FDI	ENGINEERING CHANGE ORDER			ECO NO: 17-035	
				Page 1 of 4	
TITLE	ASSY PN	CURRENT REV	NEW ASSY PN	NEW REV	
uEZGUI-4088-43WQN	AUG4043QNBA14	1.4	AUG4043QNBA2	2.0	
uEZGUI-4088-43WQN	AUG4043QN13	1.3	AUG4043QN2	2.0	
uEZGUI-4088-43WQH	AUG4043QHBA13	1.3	AUG4043QHBA2	2.0	
uEZGUI-4088-43WQH	AUG4043QH13	1.3	AUG4043QH2	2.0	
uEZGUI-4088-43WQE	AUG4043QEBA13	1.3	AUG4043QEBA2	2.0	
uEZGUI-4088-43WQE	AUG4043QE13	1.3	AUG4043QE2	2.0

BACKGROUND:

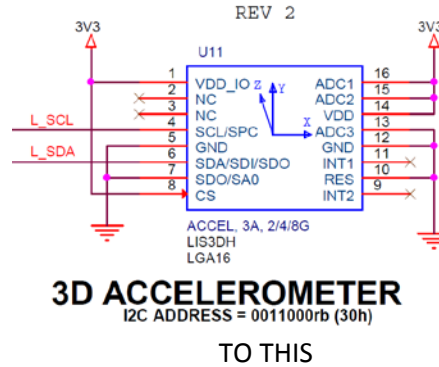
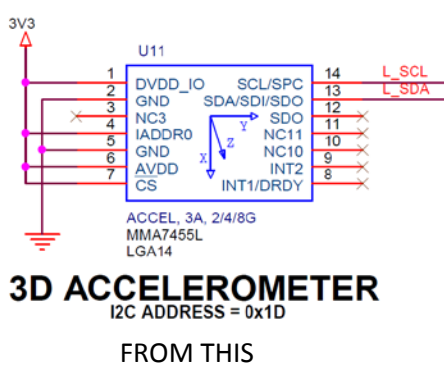
1. Change U11 from MMA7455L, FDI PN: U500437 to LIS3DH, FDI PN: U500639

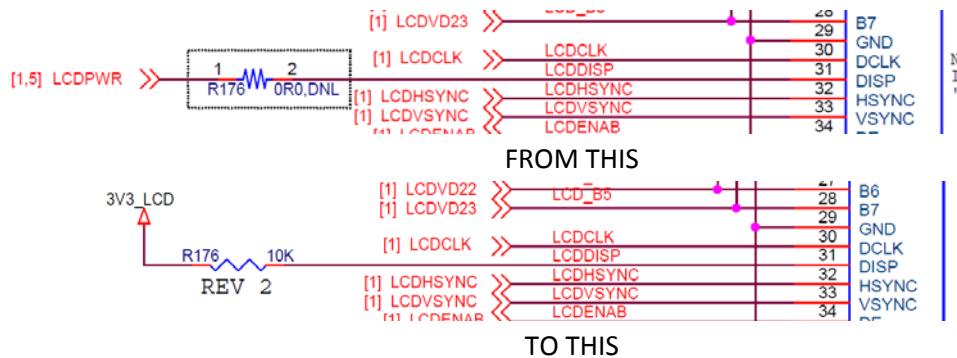
- Change R176 from series connection to MCU, to pullup to 3.3V and change value from zero ohm (DNL), FDI PN: R500436 to 10K (Loaded), FDI PN: R500029

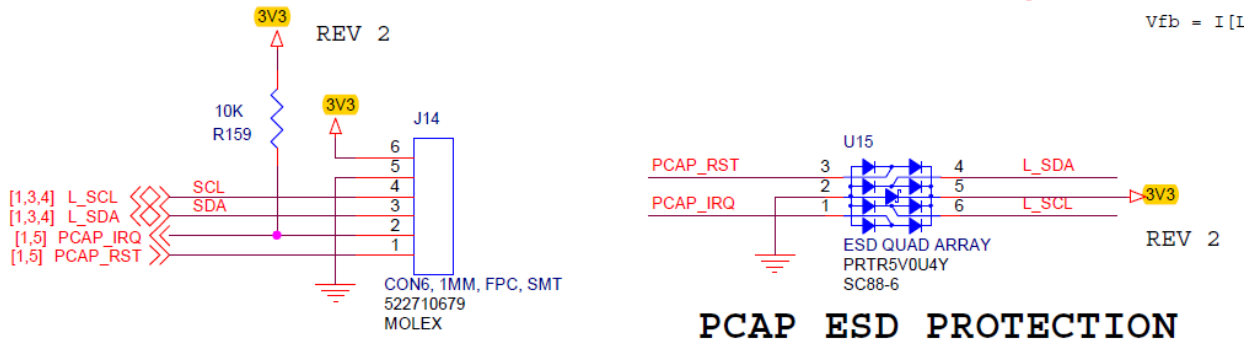
- Change LCD PCAP connector, pullup, and ESD protection from switched 3V3_LCD to non-switched 3V3, highlighted below; (no component changes)

NOTE: PINOUT OF PCAP FPC TAIL IS REVERSED FROM PINOUT OF MOLEX CONNECTOR

OPTIONAL STRAIGHT SMT
REV 2

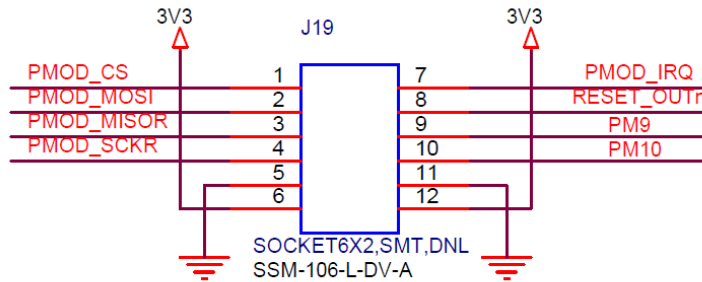
4. Add optional vertical PMOD socket (J19) for customers that require vertical mounting of PMOD;

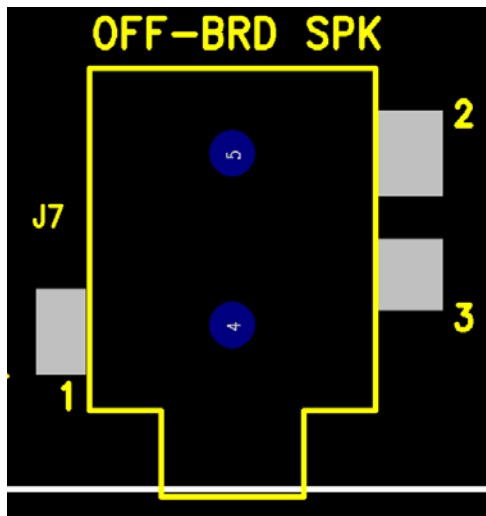
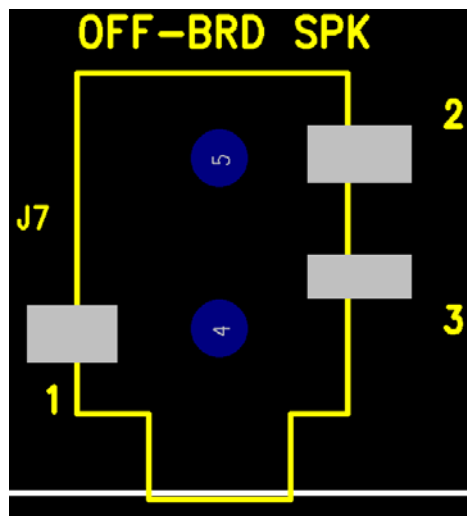
5. Change audio jack (J7) PCB footprint to support current vendor (RDI)

FROM THIS

TO THIS

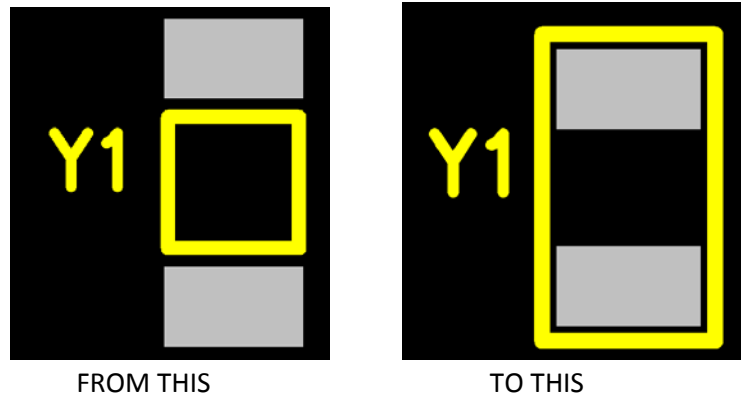
6. Change 32.768Khz crystal (Y1) PCB footprint to match current vendor for FDI PN: X500027
